**Subject: MHI's Response to US-APWR DCD RAI No. 695-4934 Revision 2 (SRP Section 06.03)**

Responses to Request for Additional Information No. 695-4934  
Revision 2

**US-APWR Design Certification  
Mitsubishi Heavy Industries  
Docket No. 52-021**

**RAI NO.:** NO. 695-4934 REVISION 2  
**SRP SECTION:** 06.03 – EMERGENCY CORE COOLING SYSTEM  
**APPLICATION SECTION:** 6.3  
**DATE OF RAI ISSUE:** 2/18/2011

RAI Figure 6.3.88-1 NaTB Solution Transfer Piping Diagram

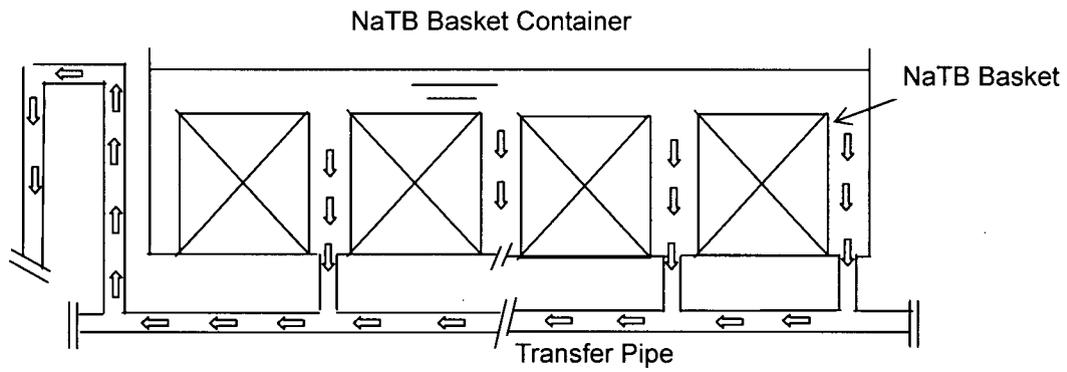
- 1) Please provide a detailed description including elevations of this flow path and where it combines with the flow path from the other basket container (See DCD Figure 6.3-12). Provide a comparison of driving head and piping pressure loss and any relevant assumptions.

- a.1) RAI Figure 6.3.88-1 shows flow paths from NaTB basket containers A, B, and C to RWSP with elevations. RAI Figure 6.3.88-1 also shows the flow rate of each path that is used to evaluate piping pressure loss. Please refer to the response to Item (c) below for the comparison of driving head and piping pressure loss, and relevant assumptions.

RAI Figure 6.3.88-2 NaTB Solution Flow Path

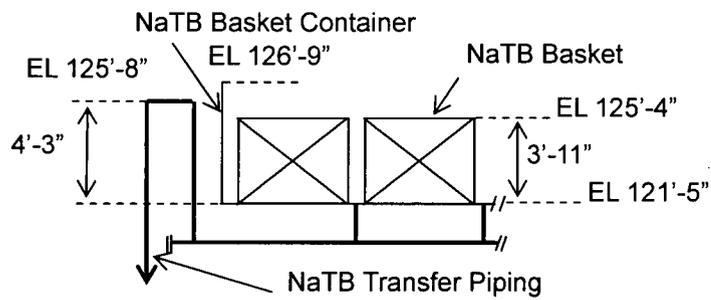
- 2) Since the piping inlet for fluid removal from the basket container appears close to the bottom of the basket container, justify that debris cannot accumulate in the lower part of

the basket container and block the flow to the RWSP.

- a.2) The piping inlets are provided between NaTB baskets in the container as shown in RAI Figure 6.3.88-2. There are no obstacles above the piping inlet at the bottom of container. Therefore, debris flows into the pipe inlet with the NaTB solution and is discharged into the RWSP without blocking the connection to the transfer pipe.

RAI Figure 6.3.88-3 Elevations around NaTB Basket

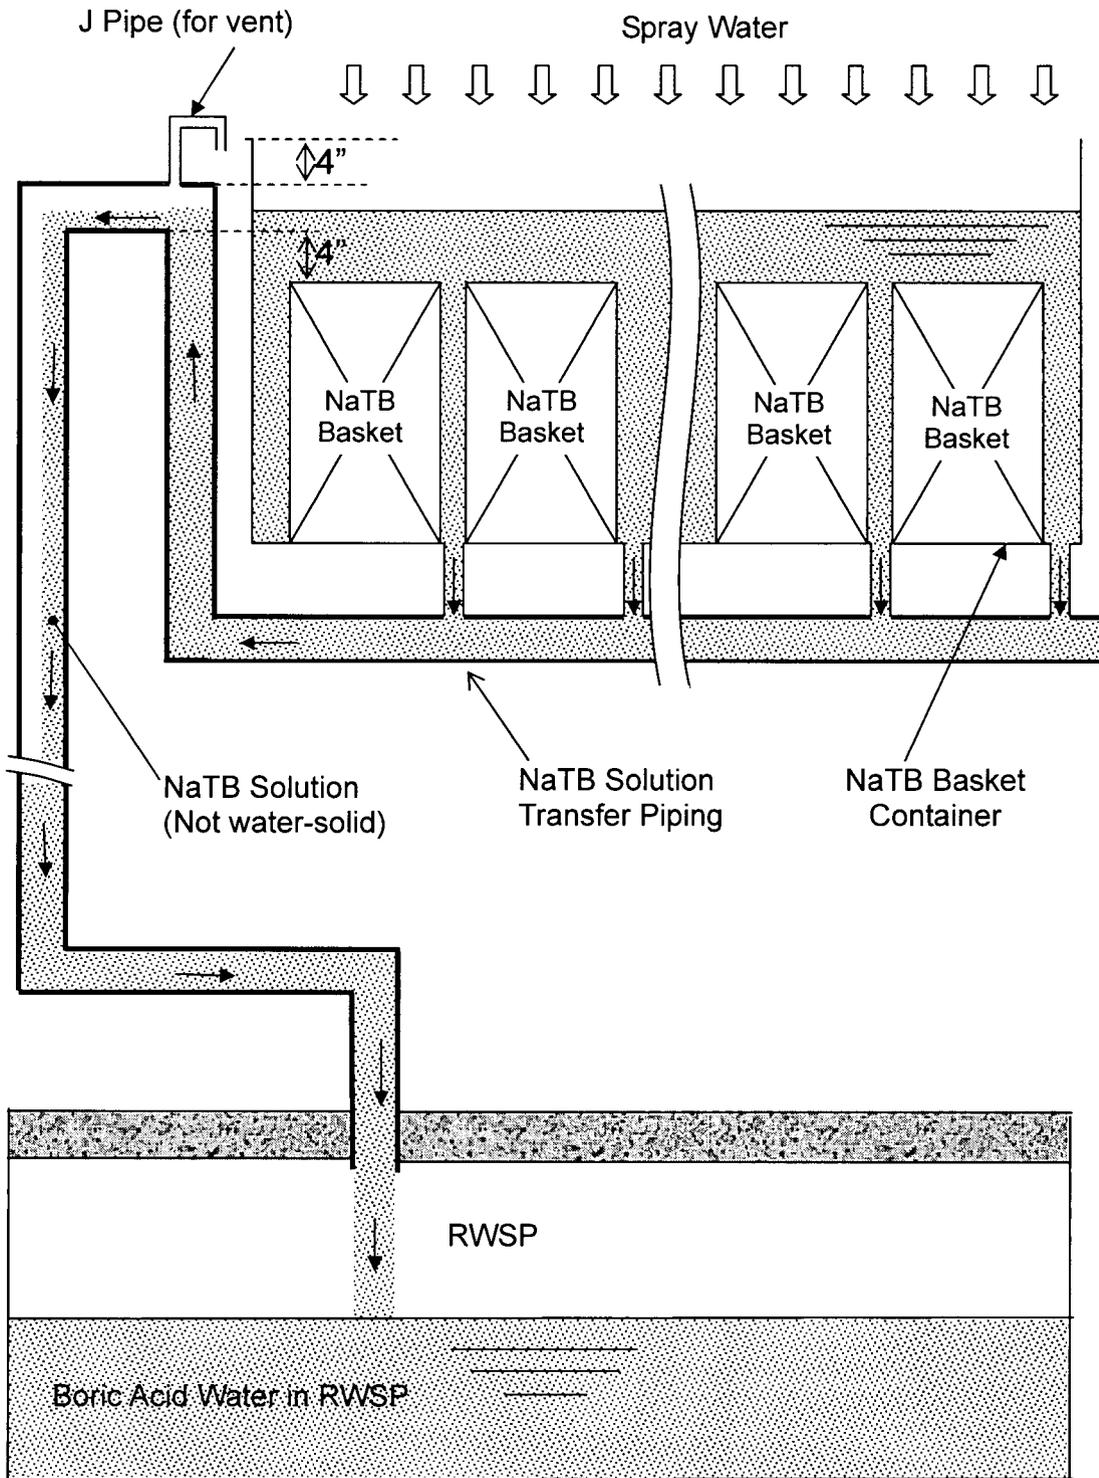
- d. In Figure 6.3-12 Note 2 states "Raise the outlet piping to a level 4'-3" higher than the bottom of the NaTB basket container and layout piping with a down slope from the outlet piping to RWSP." Figure 6.3-11 indicates that the height of the NaTB basket is 4'-11". How do you know that you are getting enough water coverage on the NaTB baskets to satisfy the design basis of maintaining the correct pH of the RWSP? Provide a calculation or discussion that supports the claim that the NaTB baskets would be fully immersed during minimum flow conditions for the containment spray ring D.

d. The height of NaTB basket is 3' -11", as shown in RAI Figure 6.3.88-3, not 4' -11" as shown in DCD Figure 6.3-11. DCD Figure 6.3-11 will be revised to include the correct value as shown below.

As shown in RAI Figure 6.3.88-4, the transfer piping exits from the bottom of the container and rises to the horizontal portion of the U-pipe. The bottom of the U-pipe is located [    ] inches higher than the top of the basket, the U-pipe is 8.625 inches in diameter, and the top of the U-pipe is approximately 4 inches below the top of the basket container. As shown in RAI Figure 6.3.88-4, the spray water flowing into the container need to overflow the bottom of the U-pipe to be transferred to the RWSP. Therefore, the water level in the container is maintained at the level 4 inches higher than the top of the basket even though the minimum flow conditions for the containment spray ring D, and the baskets are completely submerged in the spray water.
